# Enterprise Recycling & Disposal Facility

Angelo's Aggregate Materials, Ltd.

Pending Modification Permit Nos. 0177892-005-SO/MM and  
0177982-006-SC/MM

## Response to Requests for Additional Information

R:\CAD\DWG\1999\99-331\01\PHASE 5\PLAN C-2.DWG

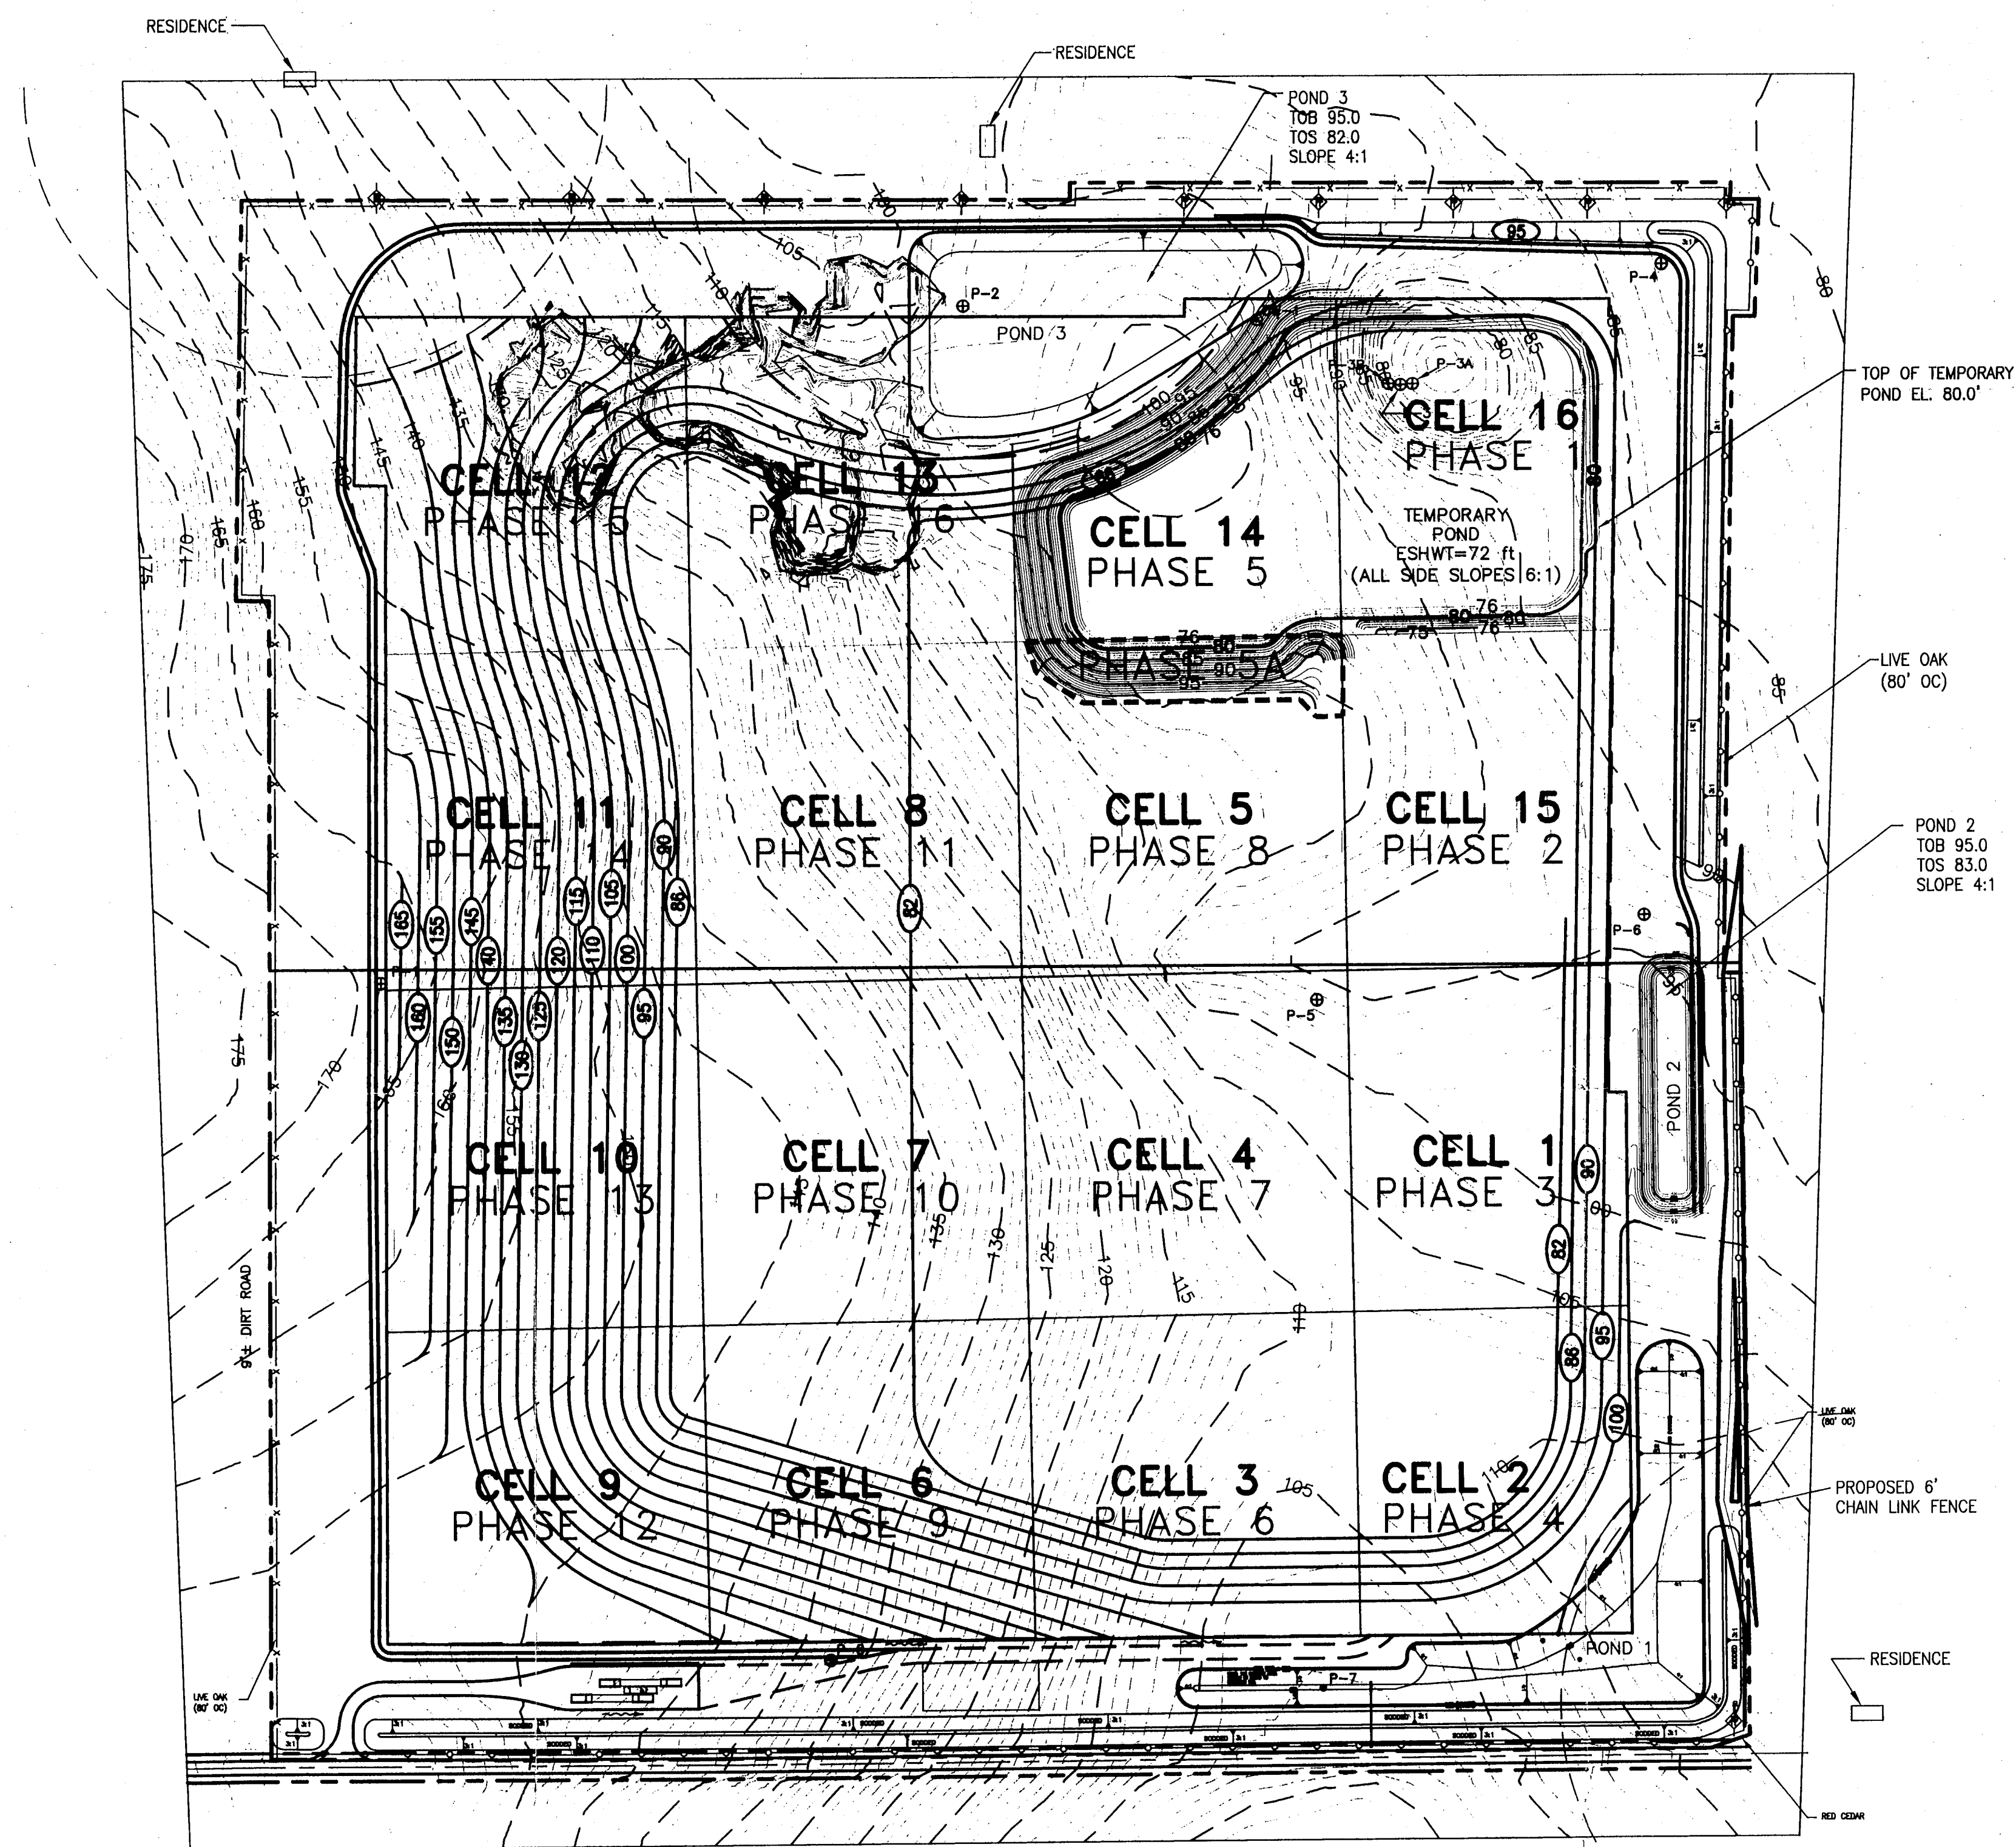
11. Response acknowledged.
12. Figure C-2 indicates that all the cells to be filled in sequences 1 and 2 will be at a base elevation of 82 feet NGVD. However, the cross-sections shown in Figures 3-26, 3-27 and 3-28 indicate that some cells will have a base elevation of 80 feet NGVD. Please revise the appropriate drawing accordingly.

11. Section 3.7 - Figure 3-7 (C-2). The sequence of excavation identified by phase numbers needs to be updated, since a portion of cell 5 will be excavated for use as part of the stormwater control system prior to filling in cell 15.

12. Section 3.7. Please provide a drawing that shows the base elevation for each of the cells to be filled in sequence 1 and 2.

**Response:** The excavation phasing, as shown on Figure 3-7 (C-2) has been revised as requested.

**Response:** The revised Figure 3-7 (C-2) illustrates the base elevations for the entire landfill.

# ENTERPRISE RECYCLING & DISPOSAL FACILITY SITE PLAN

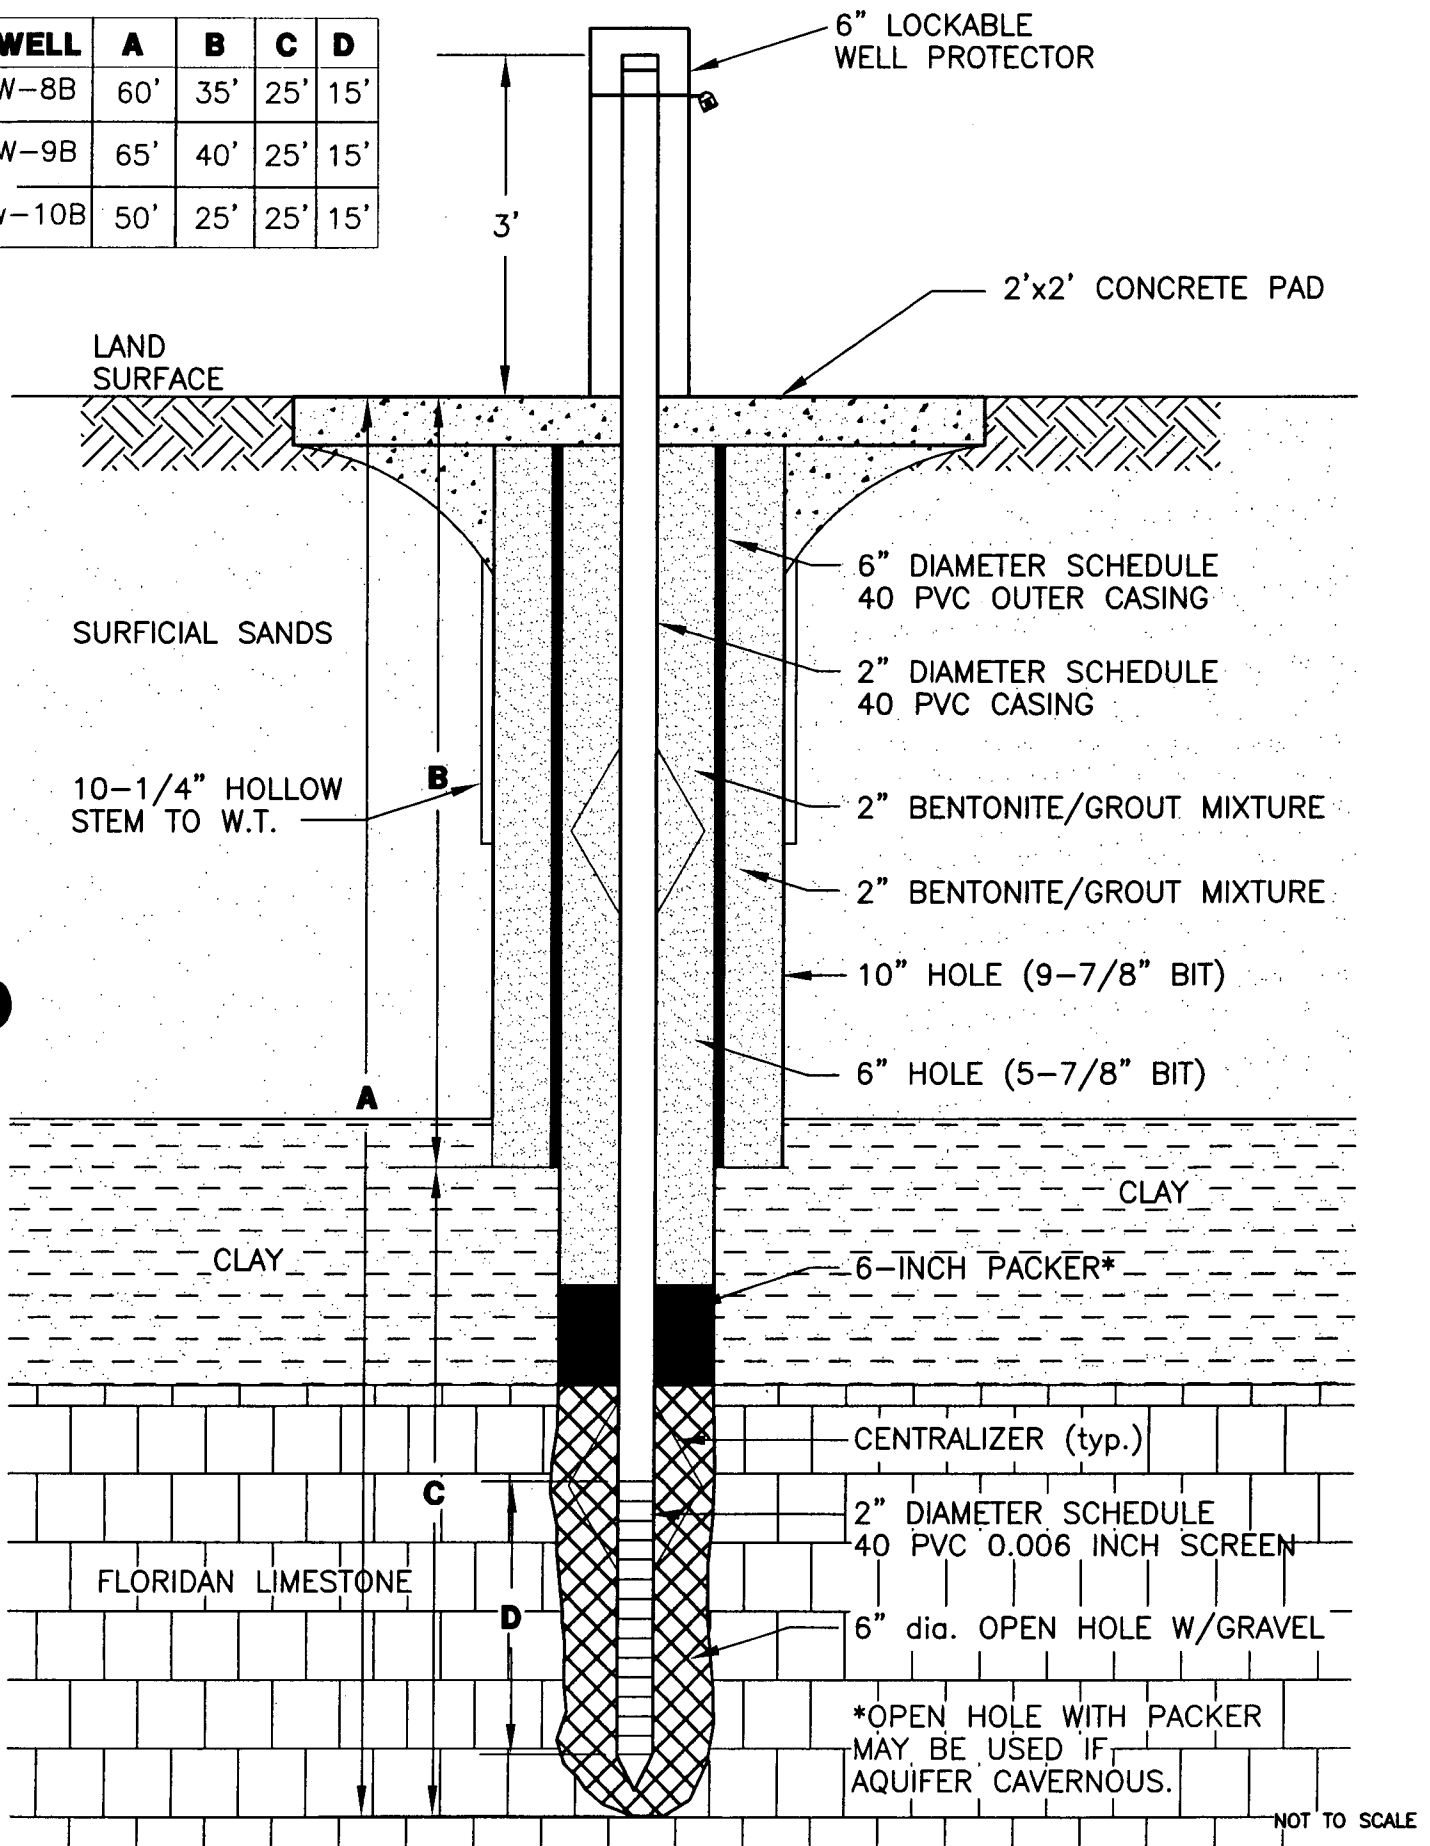
17. Sheet C-1 is not valid for illustrating the cell closure sequence since the sequence of cell closure no longer follows the cell numbers. Please provide a revised drawing using a different notation to illustrate cell closure sequence.

17. Section 3.9 – Figure C-1 is no longer valid for illustrating the cell closure sequence, since cell 15 is now part of sequence 1 and 2. Please provide a revised drawing depicting the cell closure sequence.

**Response:** As stated in the response to comment 16, Angelo's does not propose to rename the cells. Rather, closure is proposed to occur as the lifts are completed above natural grade, as described in Section 3.8 of the Engineering Report. Plan sheet C-1 has been revised to show the modified excavation phasing.
